ORIGINATION FORM

Proposed Revisions to a Standard Plans Index
(Please provide all information — Incomplete forms will be returned)

Index Number: 521-660

Index Title: Light Pole Pedestal - Bridge

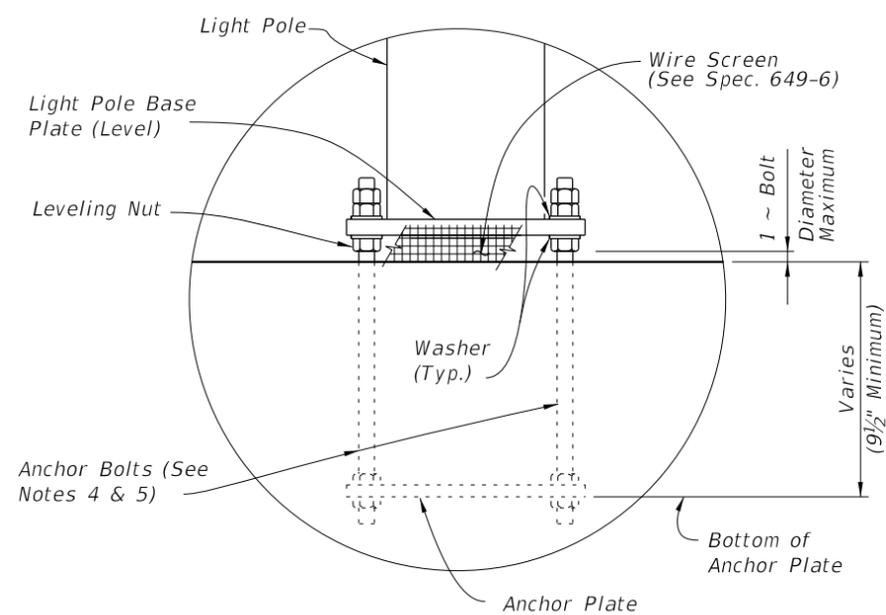
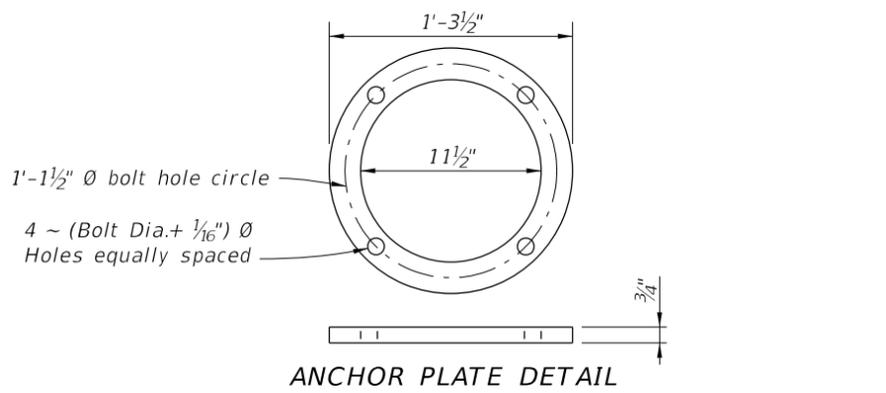
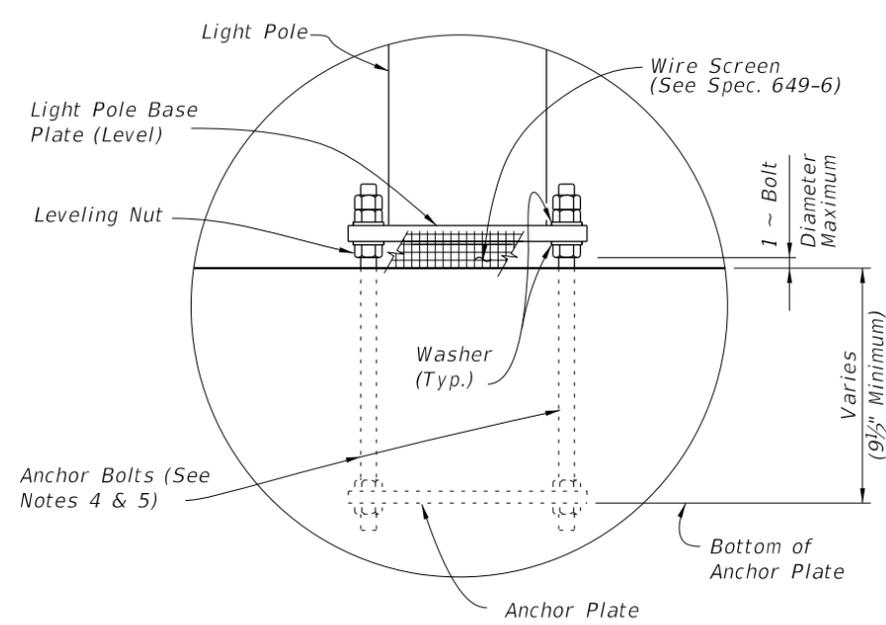
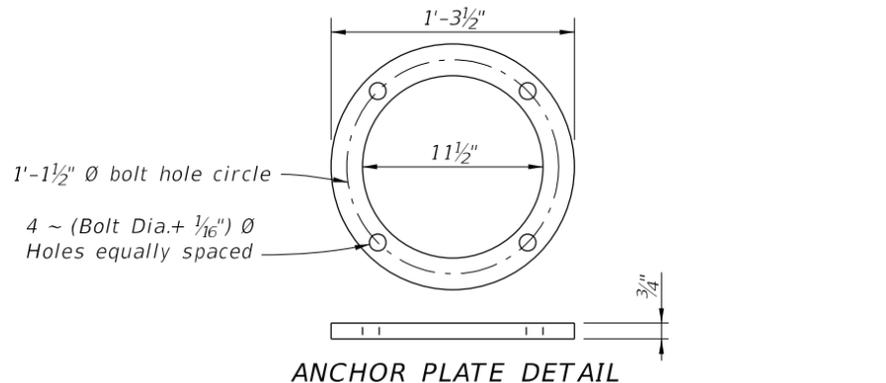
Updated wind speeds in Table 1

WIND SPEED (MPH)	ARM LENGTH (Ft.)	BRIDGE DECK HEIGHT (Ft.)*		
		40 Ft.	45 Ft.	50 Ft.
120	≤ 15	75	75	75
140	≤ 15	75	75	75
160	8 & 10	75	75	45**
170	12 & 15	75	75	25**

130
150
170
170

WIND SPEED (MPH)	ARM LENGTH (Ft.)	BRIDGE DECK HEIGHT (Ft.)*		
		DESIGN MOUNTING HEIGHT 40 Ft.	45 Ft.	50 Ft.
130	≤ 15	75	75	75
150	≤ 15	75	75	75
170	8 & 10	75	75	45**
170	12 & 15	75	75	25**
